<b>Title - Sujet</b> Building A-K Flooring Replacement	
<b>Solicitation No. - N° de l'invitation</b> EZ899-192064/A	<b>Amendment No. - N° modif.</b> 004
<b>Client Reference No. - N° de référence du client</b>	<b>Date</b> 2018-12-07
<b>GETS Reference No. - N° de référence de SEAG</b> PW-\$PWY-036-8485	
<b>File No. - N° de dossier</b> PWY-8-41177 (036)	<b>CCC No./N° CCC - FMS No./N° VME</b>
<b>Solicitation Closes - L'invitation prend fin</b> at - à 02:00 PM on - le 2018-12-14	<b>Time Zone</b> Fuseau horaire Pacific Standard Time PST
<b>F.O.B. - F.A.B.</b> <b>Plant-Usine:</b> <input type="checkbox"/> <b>Destination:</b> <input checked="" type="checkbox"/> <b>Other-Autre:</b> <input type="checkbox"/>	
<b>Address Enquiries to: - Adresser toutes questions à:</b> Martin (PWY), Delia	<b>Buyer Id - Id de l'acheteur</b> pwy036
<b>Telephone No. - N° de téléphone</b> (778) 707-2139 ( )	<b>FAX No. - N° de FAX</b> (604) 775-6633

This Amendment #004 is raised to issue Addendum #02.

Client/client <b>CORRECTIONAL SERVICE CANADA</b>	Project title/Titre du projet MISSION MEDIUM INSTITUTION 8751 STAVE LAKE STREET, MISSION, BC <b>BUILDING A-K FLOORING REPLACEMENT</b> ROOM 102, 103, 104, 121	Drawing t

3 FLOOR JOINT DETAIL AT STAINLESS STEEL DRAIN PAN  
Scale: 1:1

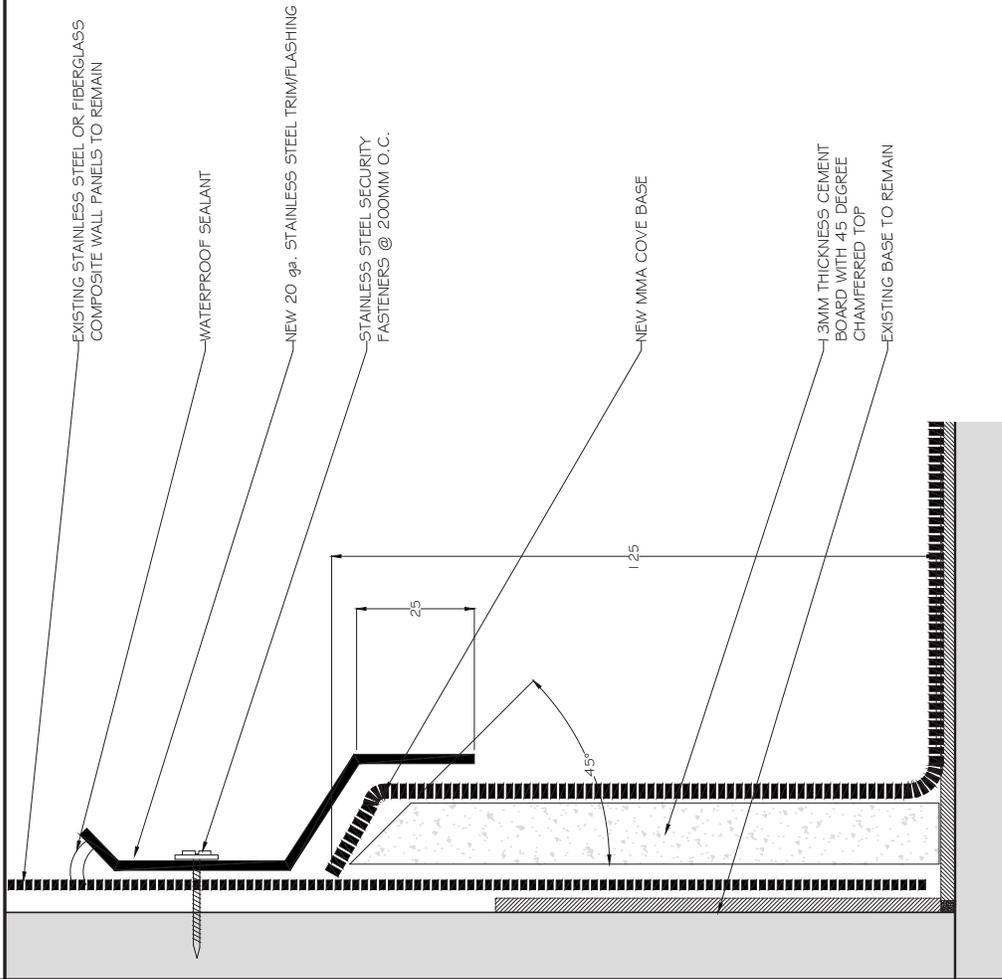
Q4: The subcontractor has checked with BASF and they will not warranty the application of MMA over the stainless steel at the floor drains. In order to get MMA to adhere to the stainless, even for a short period,

requires to roughen up the stainless with a grinder to create a profile for bond. Once the MMA wears off the now roughened stainless will be visible. Please advise if this is acceptable?

**Use the attached ASK-2 floor joint at drain pan detail.**

1 COVE DETAIL AT EXISTING STAINLESS STEEL OR FIBERGLASS WALL PANELS  
Scale: 1:1

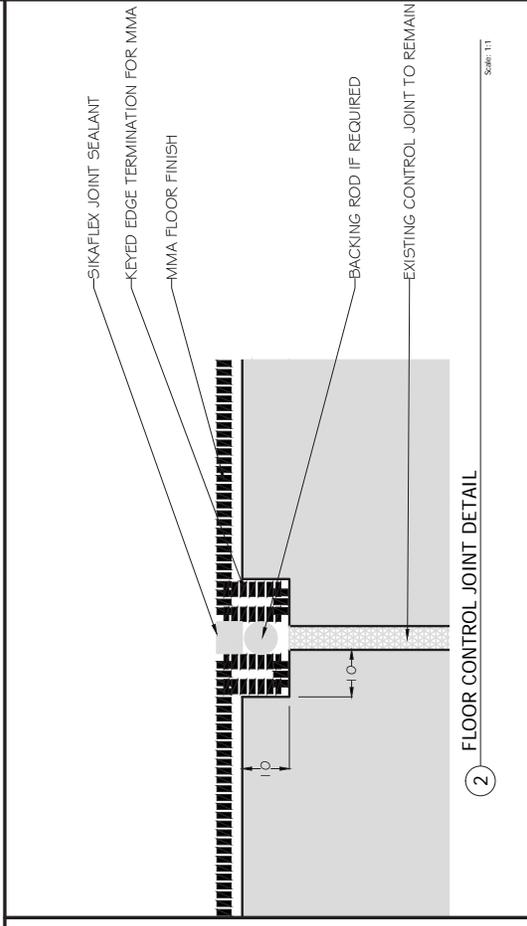
Q3: The detail on page A03 #2 125mm cove base shows the stainless steel wall sheet to be pulled away from wall. This to allow the MMA to go up behind the stainless steel wall panel and then fasten back the stainless steel panel to overlap MMA. This would be somewhat difficult to accomplish without causing more damage to the stainless steel wall panels. Another way to install MMA 125mm up walls would be to totally remove the existing S/S panels from walls and reinstall after MMA base coating return 125mm up the wall. This would require a lot of electrical fixtures, conduits and other kitchen equipment which is surface mounted to wall to be removed and replaced. Plus a lot of time absorbed and labour intensive to re and re the existing aged panels. The chance of making a good and professional locking junction at the base overlap is somewhat remote. The MMA coating return up the wall will be proud of the wall which would deflect the S/S wall panel out and away at the bottom of the sheet at this overlap. Along with the existing condition (dented, damaged and aged) of the S/S panels the overlap joint would not be that appealing or professional looking when complete. (There would be multiple surface fasteners required, oil can and a buckled look to the S/S panel would occur).

**Use the attached ASK-2 cove detail for stainless steel and fiberglass wall panel locations.**

2 FLOOR CONTROL JOINT DETAIL  
Scale: 1:1

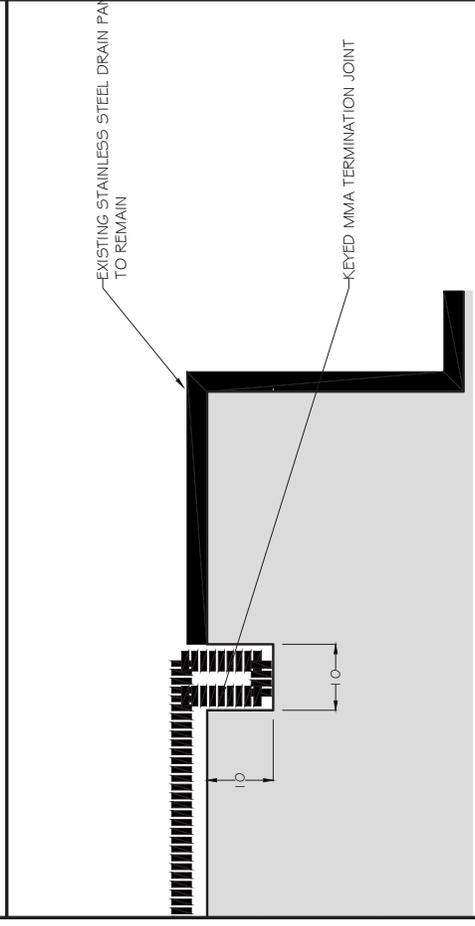
Q5: Please provide a product recommendation for material to be installed in the control joints that will be cut after the MMA is installed and cured?

**Use the attached ASK-2 floor control joint detail.**
